#### <u>AMENDMENTS TO THE DRAWINGS</u>

#### REMARKS/ARGUMENTS

Appl No. 10/790,929
Amdt. Dated Dec. 22, 2005
Reply to Office Action of Sept. 30, 2005
Annotated Sheet Showing Changes

FIG. 1

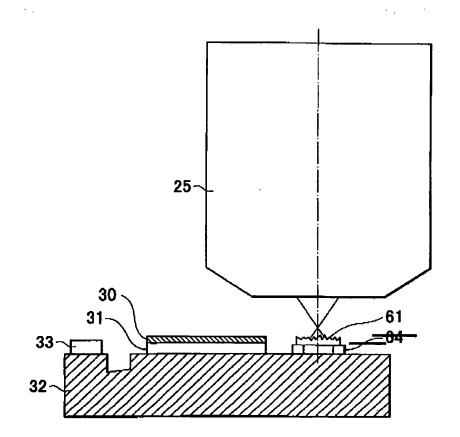
The attached sheet of drawings includes changes to Figures 1, 5, and 10. These sheets replace the original sheets including Figures 1, 5, and 10. In Figures 1, 5, and 10, previously included reference character "64" has been deleted.

The drawings were objected to as failing to comply with 37 CFR 1.84(p)(5) because they include the following reference character(s) not mentioned in the description: 64.

In response to the objection that the drawings included character 64 which was not mentioned in the description, per the replacement sheets, Figures 1, 5, and 10 have been amended to remove character 64...
